## Determination 2019/013

# Regarding the refusal to issue a code compliance certificate for the relocation of and 18-year-old alterations to a house at 9 High Street, Waddington

Figure 1: The north elevation

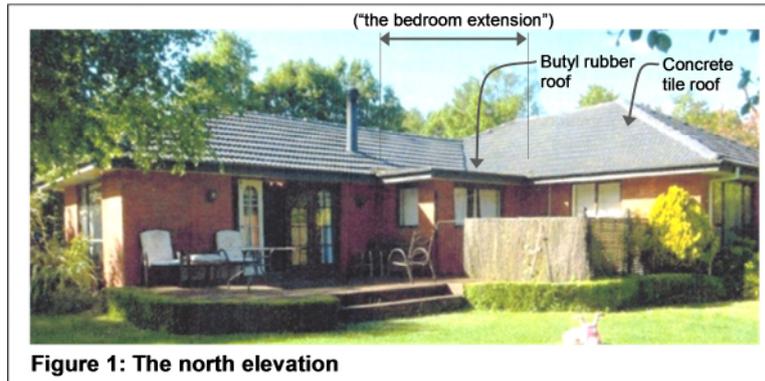
1.5.2 As the authority has limited its concerns to the matter outlined in paragraph 2.6.1 and 2.6.2, this determination is limited to the membrane roof constructed as part of building work carried out under Building Consent (No. BC990766) dated 8 November 1999. I have not considered other elements of the alterations or the original house which are remote from the bedroom extension roof as shown in Figure 1.

**Figure 2: Approximate plan**

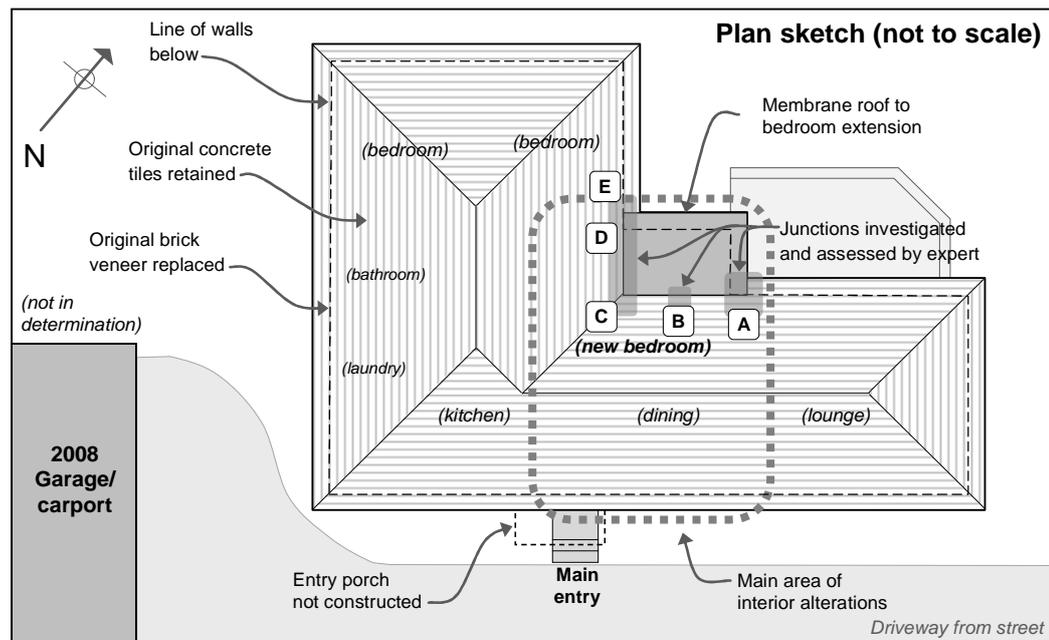
## **4.3 Destructive investigations of the membrane / tile junction (see Figure 2)**

4.3.1 The expert removed concrete tiles at the northeast end of the membrane/tile junction (Area A) to investigate the underlying construction and observed:

- an underlying metal back flashing intended to channel any water that spills over the membrane edge down into the adjacent gutter
- plastic mesh over the above junction to prevent debris entering and blocking the underlying back flashing
- a build-up of wind-blown leaf debris within the soffit cavity, but no sign of any dampness or moisture penetration despite recent heavy rain
- at the internal corner, water stains to the original soffit framing but no evidence of current moisture, with all timber apparently sound and undamaged.

4.3.2 At the southeast membrane/tile junction (Area B), the expert noted:

- the upper edge of the membrane extends up under the adjacent concrete tile and past the underlying timber tile batten
- the bottom of concrete tiles rest on the butyl, which will eventually cut through the membrane. There appeared to have been a separating element between the tiles and the membrane in the past.

4.3.3 The expert also removed concrete tiles along the southwest butyl/tile junction to investigate the underlying construction and noted the following:

- The membrane turned up to form an upstand with varying height to suit the butyl slope up under the concrete tile, but lacked any support to the membrane behind the upstands at junctions with tiles.

- In regard to the southeast end of the junction (Area C):
  - the lap joint has opened, with a ruler able to be inserted
  - old water stains and a recent damp patch on the underlying timber

- very low invasive moisture readings in the timber with the old stain.
- In regard to the northwest end of the junction (Area D):
  - the lap joint has also opened, with a ruler able to be inserted

- a damp patch from recent rain on underlying timber
  - very low invasive moisture readings in the adjacent top plate.
- In regard to the western end of the junction (Area E):

- ‘ample upstand’ to the membrane to prevent water flowing into the roof cavity
  - no support provided to the membrane at the upstand
  - no evidence of past or current moisture penetration into the soffit cavity.

- 4.4.3 To ensure compliance with Clauses E2 and B2, the expert concluded that the membrane roof to the bedroom extension required the following remedial work:

The [membrane] roof is leaking at the lap joints where they turn up the flat roof-to-pitched roof junction on the SW side of the flat roof.

Attention is required to all four sides of the [membrane] roof.
